**SUBJECT: James A. FitzPatrick Nuclear Power Plant
Docket No. 50-333
Response To NRC Request for Additional Information
Regarding FitzPatrick's Proposed Exemption Request
For Hemyc Fire Wrap (TAC No. MC7995)**

Attachment 1 to JAFP-06-0079
Entergy Nuclear Operations, Inc. – FitzPatrick
Docket No. 50-333
Response to Request for Additional Information (RAI)

Page 1 of 3
(Support RFSK-1827 Diagram and Photographs)

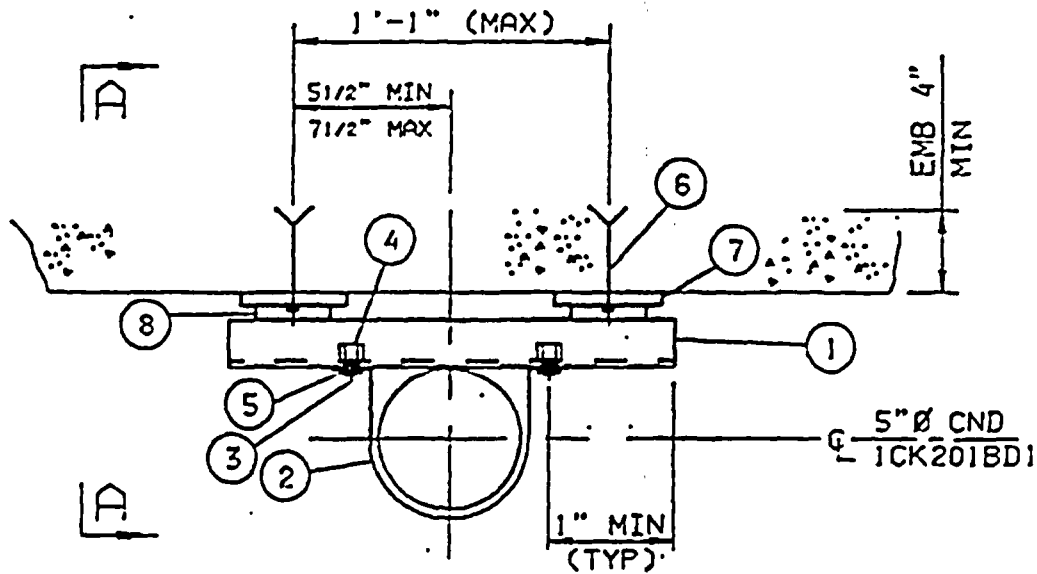
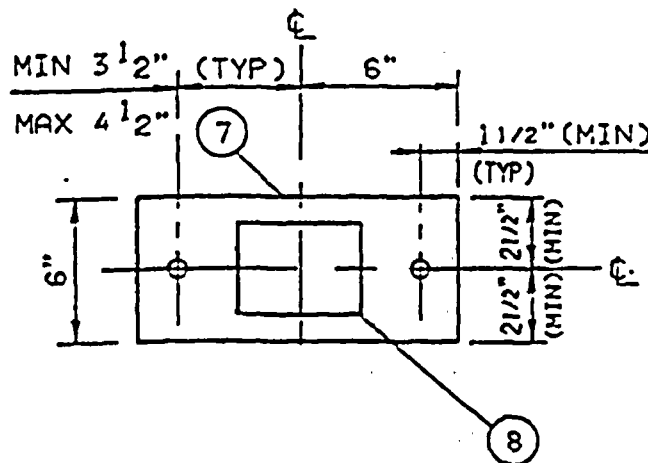
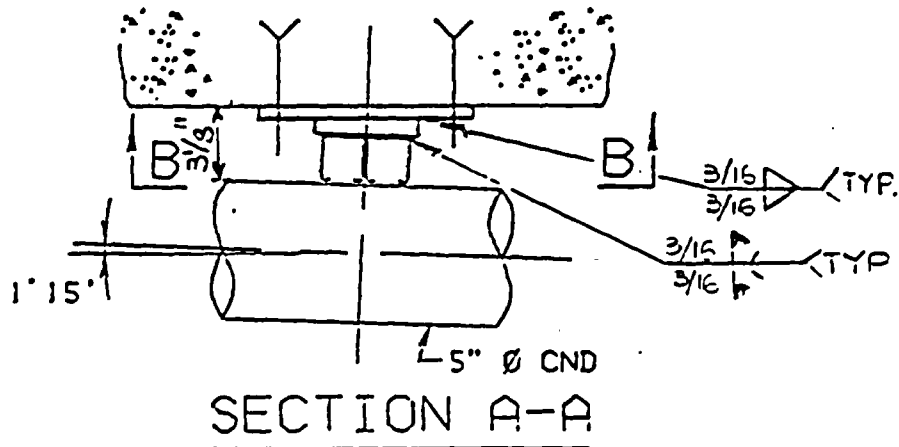
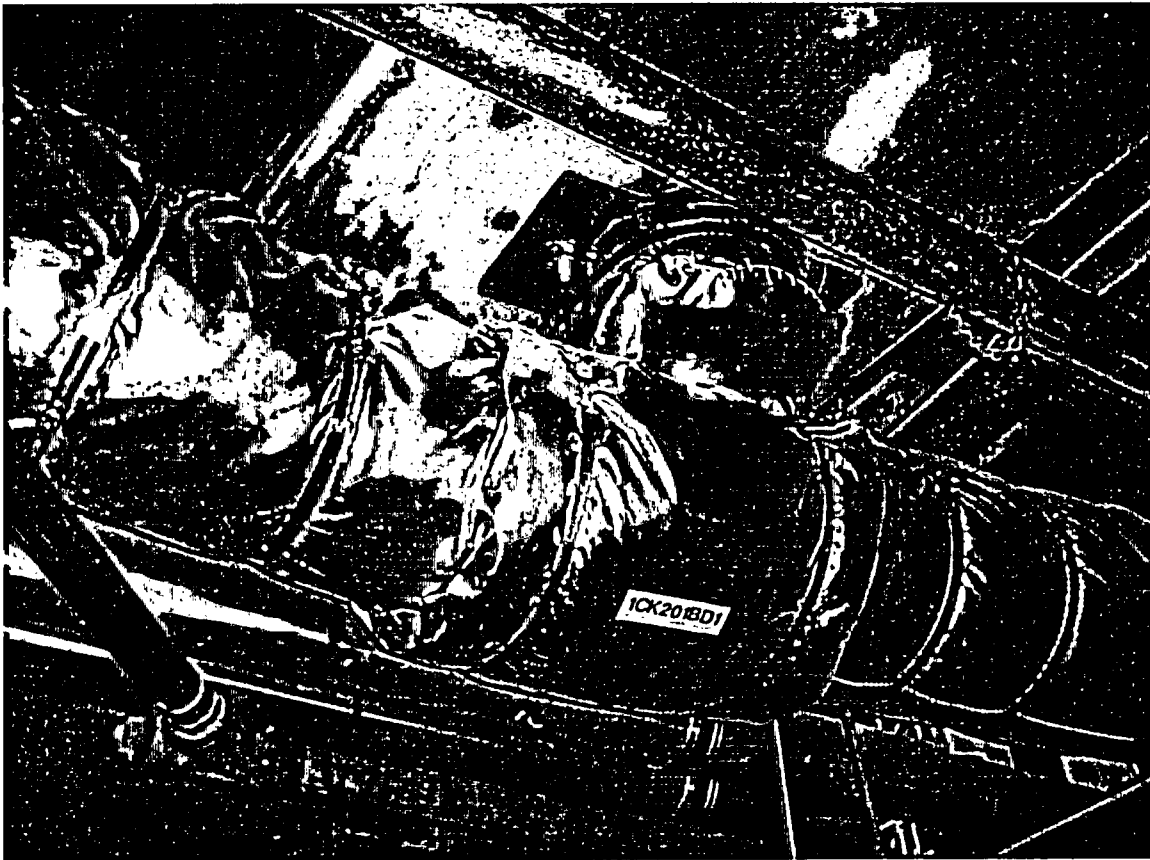
The submittal describes Hemyc wrapped structural supports. Steel supports were tested by the NRC separately from the conduit and found to fail as early as 13 minutes into the event. The additional heat load transferred to the conduit by the steel supports was not considered in the conduit tests. The FitzPatrick configuration is described as including five structural supports, completely wrapped except for a portion of the base plate. How has it been determined that the heat transfer from the exposed base plate would not adversely affect the protected cable? In the event of a fire, what would be the impact of heat transfer from the uncovered base plate through the supports to the conduit? In responding to these questions, please include the distance from the baseplate to the conduit containing the cable, and quantify the distance into an hourly rating using the NRC testing for similar supporting structures (angle iron, unistrut). Please also include the area of the base plate that is uncovered.

The structural support base plates are described as mounted in place with Hilti bolts to the concrete ceiling. Are these bolts covered by fire wrap? In the event of an intense fire, could concrete spalling compromise the ability of these bolts to function? If not, why not?

varies, but is roughly the outer 2 inches on either end of the 6 inch by 12 inch plates, and roughly the outer 2 ½ inches on the exposed perpendicular edges and approximately 5 inches exposed at the corners of the 12 inch by 12 inch plate. The distance between the uncovered base plate and the conduit containing the cable is just over 5" for the limiting case. This was determined for support RFSK-1827, considering a linear distance from the uncovered base plate, across the wrapped portion of the base plate, the solid steel spacers, the double unistrut to the point where the conduit with the cable makes contact with the unistrut. See Attachments 3 through 8 for diagrams and photographs of the Hemyc wrapped supports.

The Hilti Kwik Bolt II bolts used to secure the structural supports in place are not entirely covered by the Hemyc fire wrap as seen in the attached photographs. At the time the Hemyc wrap was installed, the need to wrap the base plates and Hilti bolts was evaluated using the guidance contained in NRC Generic Letter 86-10 (Reference 6) and it was determined that wrap was not required.
